# Access Compliance Report

## Public Rights-of-Way

### (Curb Ramps)

Intersection ID: 12618	Main Street: E_5TH_ST	Cross Street: N_CALDWELL_ST	Location: NE
ADA ID: 0E81EC665497	Ramp Type: Perp	Initial Pass/Fail: Fail	Overall Compliance: No
			Severity Score: 13.75

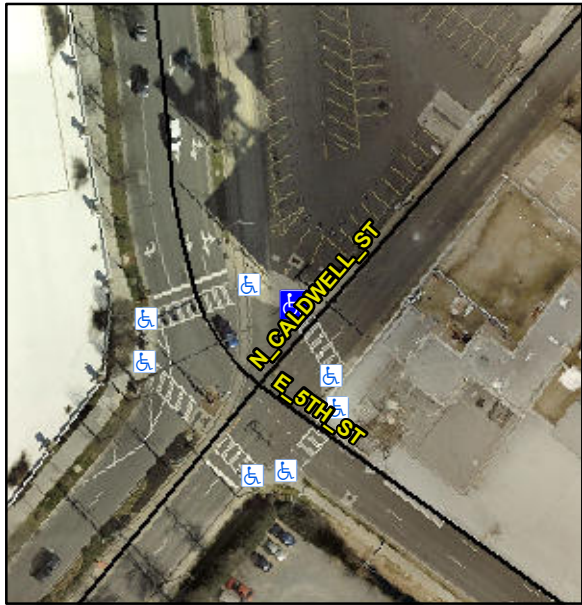
Codes/Mitigation Info/Possible Solution			Field Measurements/Component Compliance					
	Possible Solutions:		Compliance	Description	Data	Compliance	Description	Data
	Remove & Replace Entire Ramp.		N/A	Ramp Length (in)	78.0	No	Ramp Slope (%)	10.1
			Yes	Ramp Width (in)	48.0	Yes	Ramp XSlope (%)	2.8
			N/A	Flare Type LT	N/A	N/A	Flare Type RT	N/A
			N/A	Flare Slope LT (%)	N/A	N/A	Flare Slope RT (%)	N/A
			N/A	Flare Traversable LT?	N/A	N/A	Flare Traversable RT?	N/A
			N/A	Landing Length (in)	N/A	N/A	DWS Provided?	N/A
			N/A	Landing Width (in)	N/A	N/A	DWS Contrast?	N/A
			N/A	Landing Slope (%)	N/A	N/A	DWS Length (in)	N/A
			N/A	Landing X Slope (%)	N/A	N/A	DWS Full Width?	N/A
Surveyor Notes:			N/A	Landing Curb? (Y/N)	N/A	N/A	DWS Offset (in)	N/A
N/A			N/A	Shared Landing?	N/A			
PROW/ADA:			N/A	Gutter Ponding?	N/A	N/A	Gutter Slope (%)	N/A
Not Found, R304.2.2			N/A	Gutter Lip Ht (in)	N/A	N/A	Gutter X Slope (%)	N/A

N/A	Painted X Walk1?	Yes	N/A	Painted X Walk2?	N/A
				X Walk 1 Direction	To SE		X Walk 2 Direction	N/A
			N/A	X Walk 1 Width (in)	117.0	N/A	X Walk 2 Width (in)	N/A
				X Walk 1 Slope (%)	1.4		X Walk 2 Slope (%)	N/A
				X Walk 1 X Slope (%)	3.4		X Walk 2 X Slope (%)	N/A
			N/A	Ramp inside XWalk1?	Yes	N/A	Ramp inside XWalk2?	N/A
				Road Slope (%)	N/A	N/A	Clear Space?	N/A
				Road X Slope (%)	N/A	N/A	Clear Space to XWalk (in)	N/A
			N/A	Any Obstructions?	N/A	N/A	Storm Grate/Utility Hazard?	N/A
				Obstruction Type			Storm Grate/Utility Type	
					N/A			N/A
						Yes	Surface Condition? (G/P)	Good
